# TECHNICAL SERVICE BULLETIN

Technical Service Bulletin: 55-1728

# TECHNICAL SERVICE BULLETIN 55-1728 REMEDY INSTRUCTIONS

Make(s): ISATA, FORCE & EUROPA Model(s): MANY, SEE BELOW Model Year(s): 2023 - 2024	Repair Code: SB-397-03-00-004495 Allotted Time: 1.50 HRS. Inspection Code: N/A Allotted Time: N/A
	Concern: Add a bypass to the recirculation line to prevent antifreeze from contacting the AquaGO flow sensor.	Photo(s) Required: YES Prior Authorization Required: YES Part(s) Number: F100528786 Part(s) Return: N/A

**PHOTO ON THE NEXT PAGE FOR REFERENCE.**

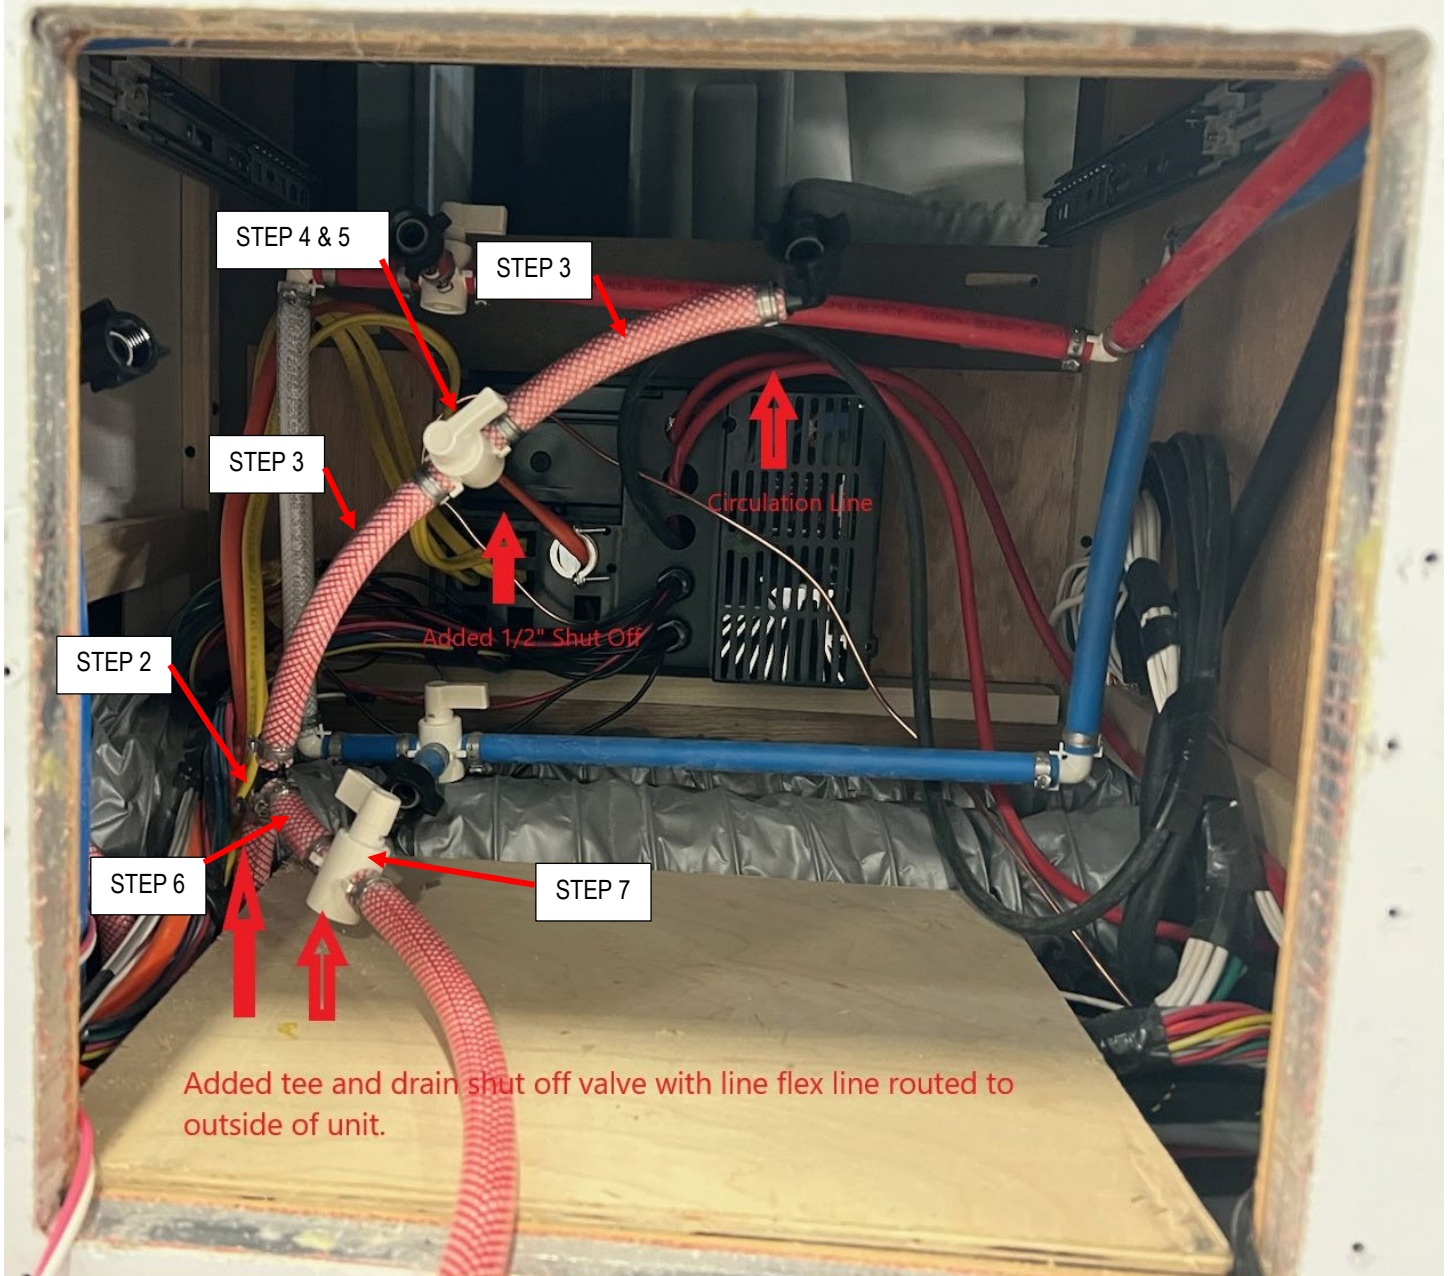
The manufacturing plant would like to install an additional bypass on the recirculation line for the AquaGo Comfort Plus system. The current bypass will not prevent the antifreeze from contacting the flow sensor. **This TSB will expire on February 28, 2026, or at the end of the Forest River's Manufacture Warranty, whichever occurs first.**

STEP 1: ACCESS THE AQUAGO CURRENT RECIRCULATION LINE;

STEP 2: CUT CURRENT RECIRCULATION LINE BY THE PLATFORM THE AQUAGO SITS ON;

- A. INSTALL A "T" IN THE CURRENT RECIRCULATION HOSE BY THE PLATFORM;
- B. USE THE PROPER CRIMP RINGS TO SECURE "T" TO HOSE;

STEP 3: INSTALL THE RECIRCULATION THAT WAS CUT OFF TO THE TOP OF THE "T" THAT WAS INSTALLED;

STEP 4: CUT THE RECIRCULATION HOSE HALFWAY BETWEEN THE NEWLY INSTALLED "T" AND THE BLACK THREADED END;

STEP 5: INSTALL A 1/2" SHUT OFF;

STEP 6: INSTALL A 12" LONG PIECE OF RED HOSE TO THE "T" THAT WAS INSTALLED BY THE PLATFORM;

STEP 7: STEP 5: INSTALL A 1/2" SHUT OFF TO THE NEW 12" LINE;

STEP 8: ROUTE THE OTHER END OF THIS HOSE THE EXTERIOR OF THE VEHICLE FOR PROPER DRAINAGE;
